1978 - 1979 Corvette: Service Bulletin: Glass Roof Panel Trim Separation

Subject: Glass Roof Panel Trim Molding Separation

Number: 79-T-7

SECTION A-A

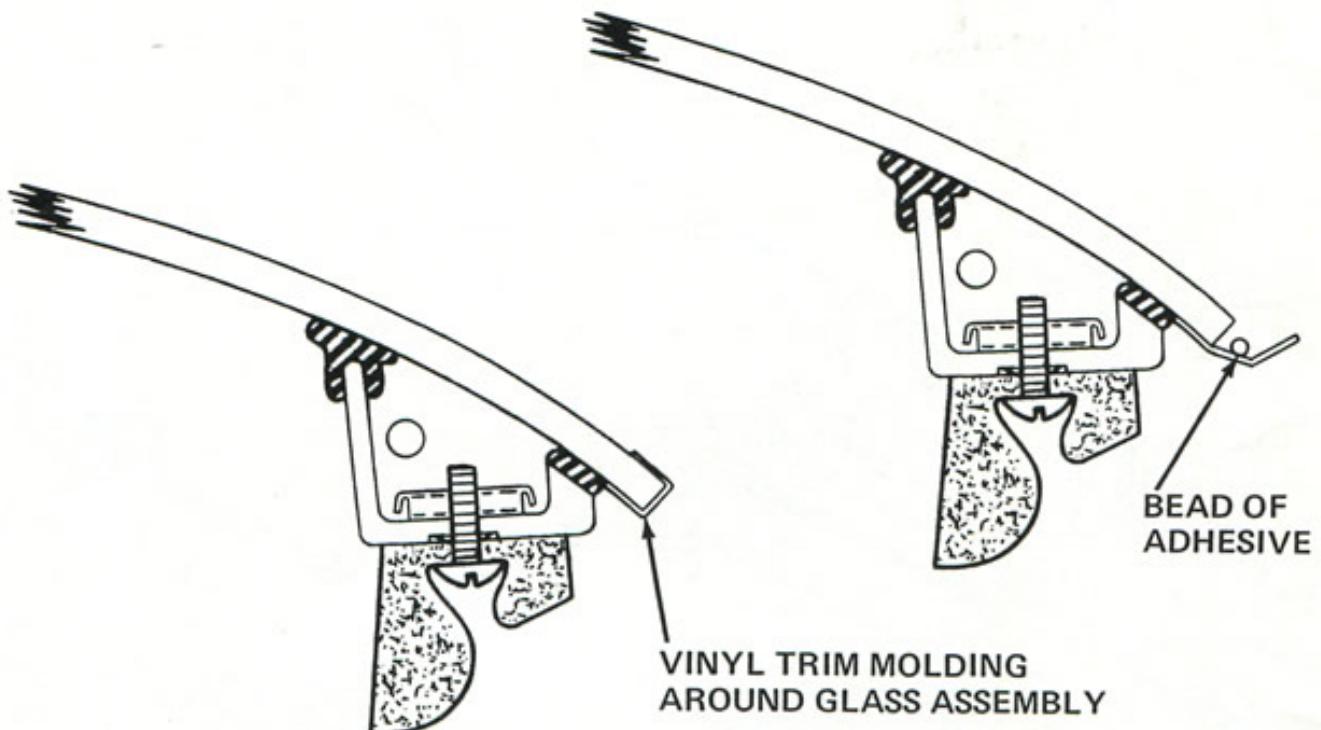
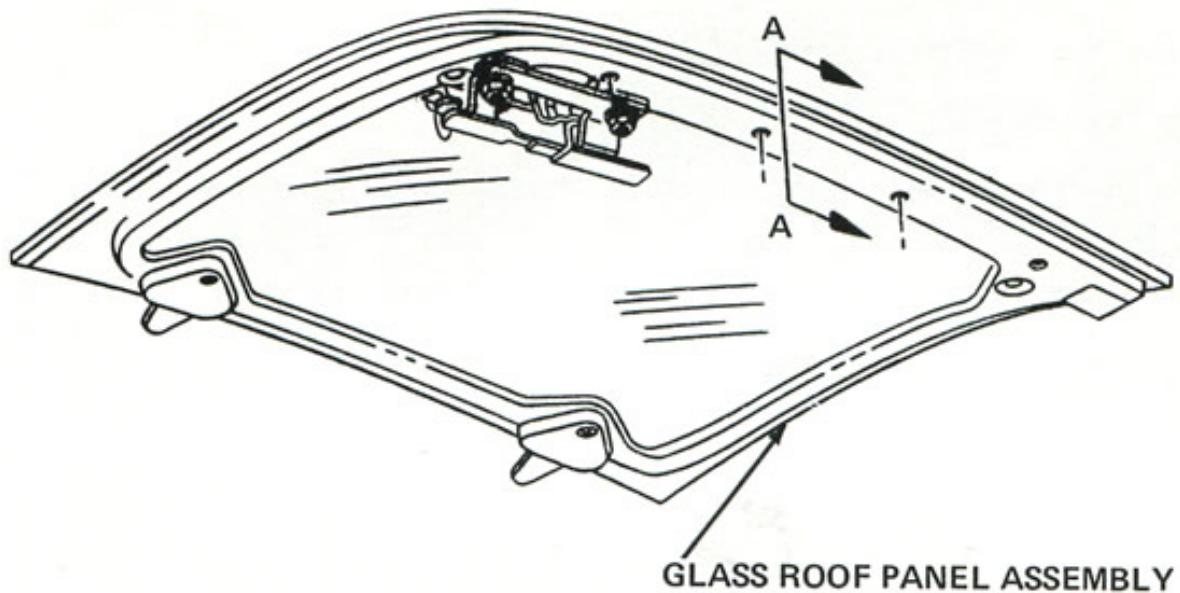
A few 1978-79 Corvettes equipped with the RPO CC1 glass roof panel may exhibit the condition of the vinyl trim molding separating from the glass panel.

The recommended service correction is application of a two part epoxy, such as 3M P/N 8640, or equivalent between the glass panel and the molding.

1. Remove the roof panel from the vehicle, but do not separate the glass from its frame.
2. In the area to be bonded, clean both the molding channel and glass thoroughly with a dry cloth to remove dirt and loose adhesive.
3. Mix epoxy as directed on package. Note cautions and curing time.
4. Transfer the adhesive into a small plastic bag ("baggie") and twist to push the adhesive into a corner. Cut off this corner to provide the proper bead size of approximately 1/16 inch diameter.
5. Apply a 1/16 inch diameter bead of adhesive into the molding channel, as illustrated, and place the channel firmly over the glass edge, allowing the excess adhesive to squeeze out.
6. After the "squeeze out" becomes firm, remove it carefully with a dull blade.
7. Allow approximately one hour cure time at room temperature before

reinstalling the roof panel.
